Aircraft Design Certification GmbH Reichensteinstr.48 69151 Neckargemünd		BRM Aero - replacement of oil cooler DC-045	Doc-Nr: ADxC-73-SB-015 Issue: A Date: 26.08.2022 ChangeNr.: ADxC-DC-73-045
Service Bulletin

Replacement of original type design oil cooler by larger oil cooler to increase cooling capacity.  
Subsequent modification of cowling to fit to the larger oil cooler.

Increase of cooling capacity of the oil cooler for hot and high operation for ROTAX Engine Type 912 (Series)

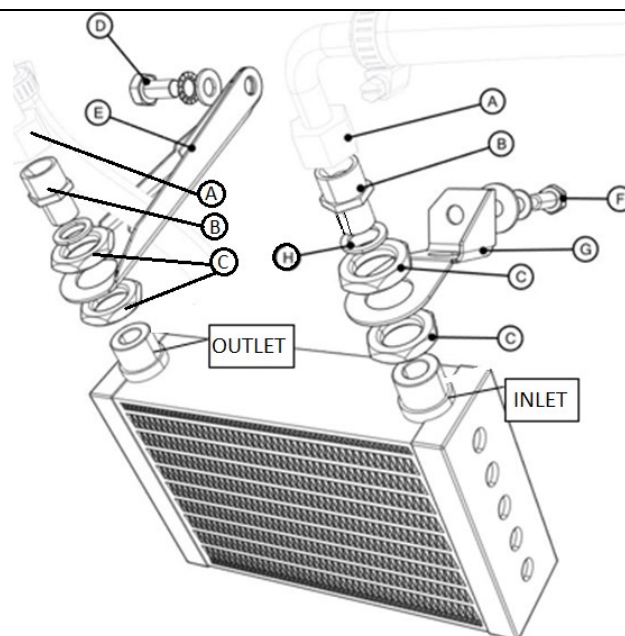
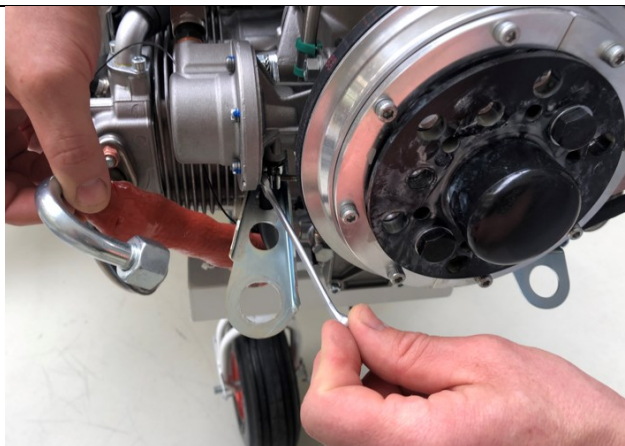
- 3) Unscrew the inlet and outlet hoses (**A** ; wrench size 19mm and 22mm)  
*Note: A small amount of oil may leak from the hoses, use a container to capture.*

- 4) Remove both the inlet and outlet adapters (ADAPTER M18x1.5/M14x1.5 **B** ; PN 000780, wrench Size 19mm). Clean and check for reinstallation.
- 5) Remove all 4 nuts fixing the radiator in the brackets (**C** ; a very flat wrench size 30mm is needed for the bottom nuts). Remove the radiator (watch out for oil in the radiator).  
*Note: A protective hose falls out of the space behind the radiator (between radiator and oil pump). Keep it for the re-installation.*

- 6) Unscrew the bolt holding the left (inlet) bracket (**F** ; wrench size 13mm).  
*Note: Cut the safety lock wire on the bolt before this step.*
- 7) Remove the left (**G** ; inlet) bracket.

- 8) Install the new left bracket 71B230051N and gently screw the bolt in (**G** ; without tightening).
- 9) Release the hose clamp of the fuel pump drain hose routed through the right bracket (on the fuel pump side; wrench size 7).

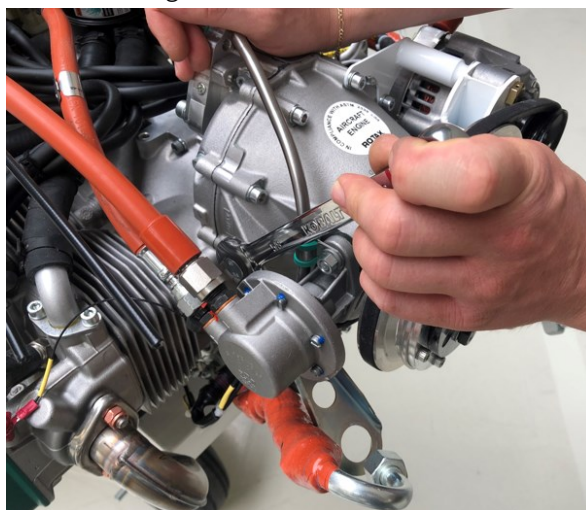
- 10) Unscrew the bolt of the right bracket M10x20 (D ; wrench size 16mm or 17mm).

- 11) Disconnect the fuel pump drain hose on the fuel pump side and remove the right (outlet) bracket (E)  
*Note: this is a good moment to check the drain hose being unobstructed, by simply blowing into it.*
- 12) Position the new right bracket 71B230052N (E), route the fuel pump drain hose through the second largest opening (see below) and re-connect the drain hose to the fuel pump again and secure with the hose clamp.

- 13) Bolt the right bracket using the bolt and washer removed in step 10)

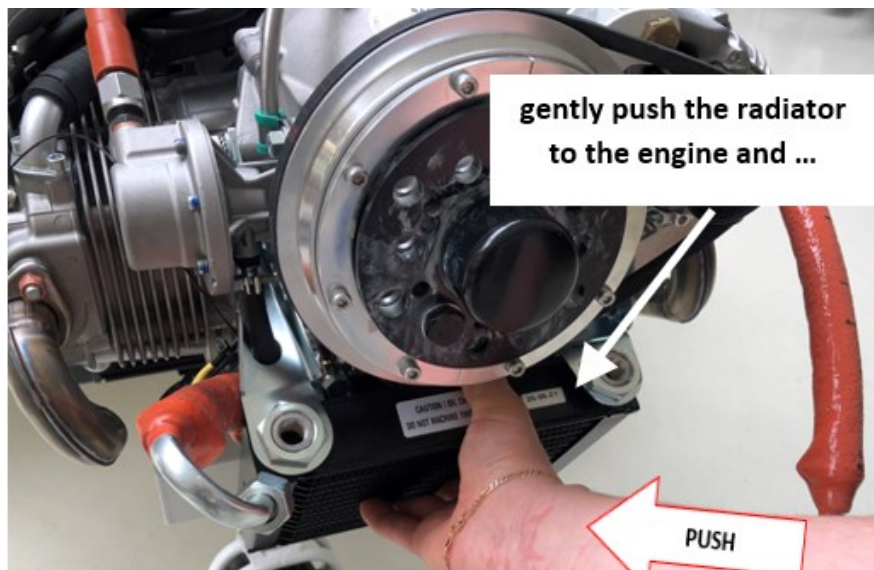
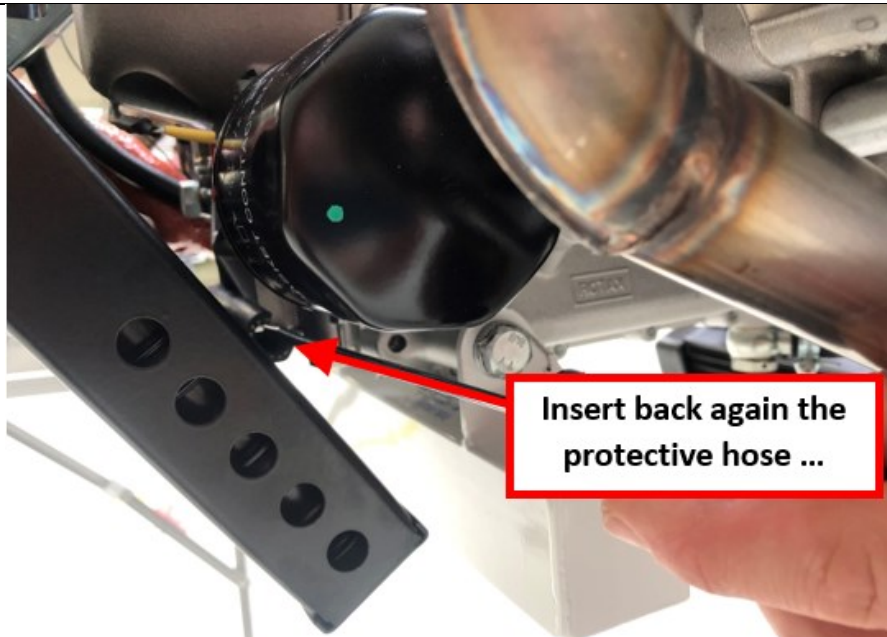
- 14) Use the replacement oil radiator P/N 886107, apply Loctite 243 to the inlet/outlet thread and screw the lower nut on both the radiator inlet and outlet threads.

*Note: before any action with the oil cooler is performed inspect the cooler for transport damage and check presence of caps preventing contamination of the cooler. If no caps are present, or in case of doubt, flush the oil cooler thoroughly. After removing the caps extreme care must be exercised to avoid entry of any objects.*

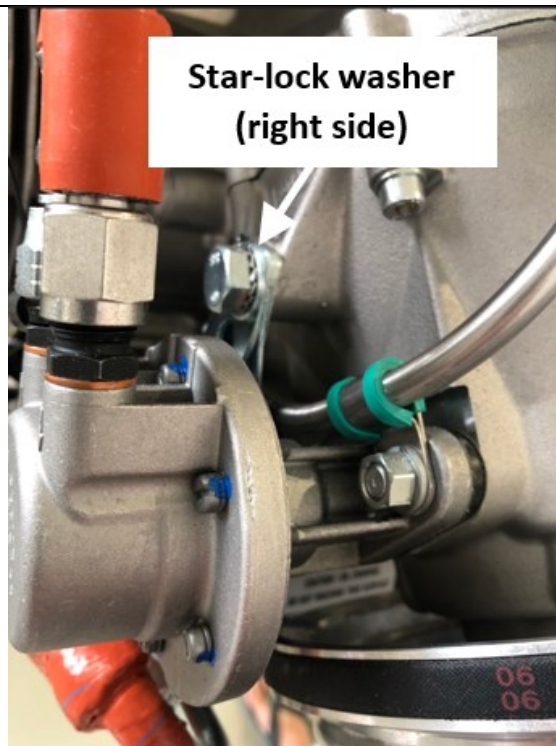
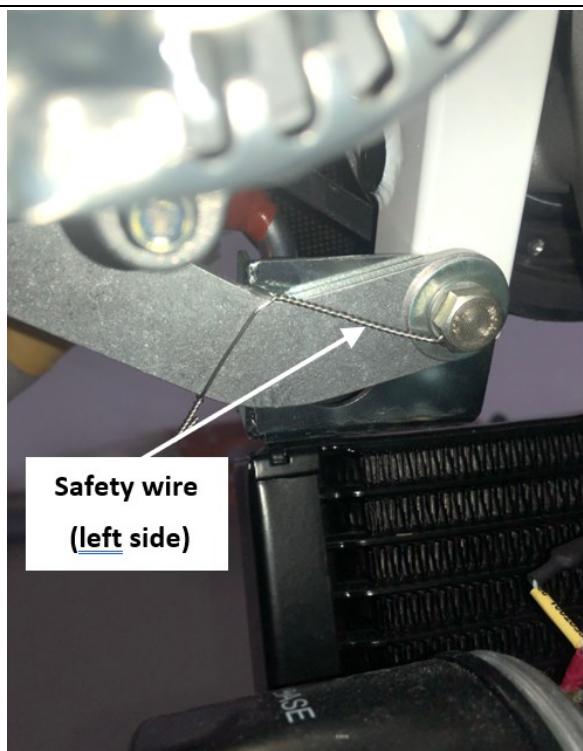
- 15) Apply Loctite 243 to the thread again and mount the oil radiator on the brackets so that the upper nut is approximately flush with the inlet/outlet tube ends.

- 16) Tighten the lower nuts against the bracket (torque moment: M8 20-22Nm M10 40-42Nm)
- 17) Insert back again the protective hose (see the Note in step 5) between the radiator and the oil pump, gently push the radiator to the engine and tighten the bolts fixing the brackets to the engine (left/right). Secure with safety wire on the LHS and with new installed star-lock washer on the RHS (see pictures below)

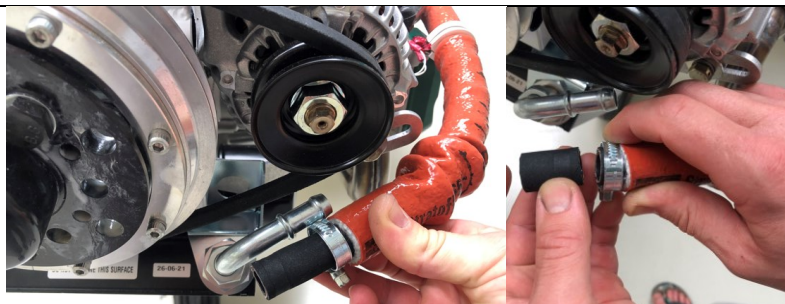
- 18) Install a new washer (H ; copper washer 20x14x1,5) on the reduction (B)
- 19) Apply sealing Loctite 577 to both reduction nuts (they must be cleaned oil free), screw the reductions in the radiator and tighten with a wrench size 19.

#### Modification of the lower engine cowling

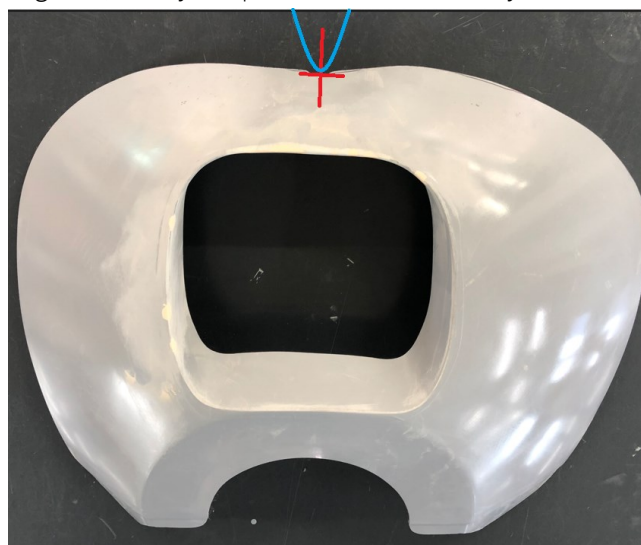
- 1) Cut-out the inlet opening in the engine cowling so that the replacement inlet part fits into the cowling. This is preliminary cut and does not require specific tolerances.

- 2) Position the replacement inlet part to the cowling so that the NACA inlets (shown blue) are aligned (modify the pre-cut-out if necessary)

- 3) Install the cowling on the airplane and check again that the NACA inlets are aligned, and the inlet position corresponds to the oil radiator correctly. If needed, make according adjustments.

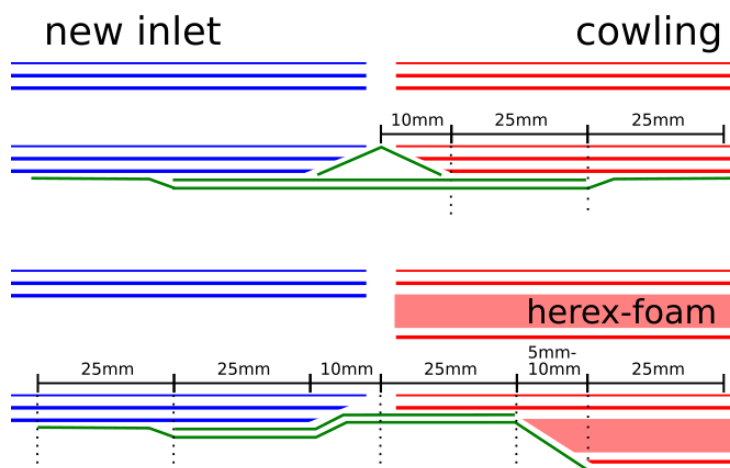
- 7) Following the outlined shape make an accurate cut-out in the engine cowling. (in red marked the pre-cut-out area that is already removed)

- 8) Remove the peel ply fabric from inside of the replacement inlet part.
- 9) From the outside of the cowling, apply the position the inlet part into the cowling cut-out and fasten it thoroughly from the outside with tape. Inside the cowling, grind the composite parts around the cut-out as shown in the schematics below (depending if herex-foam is part of the lay-up or not)
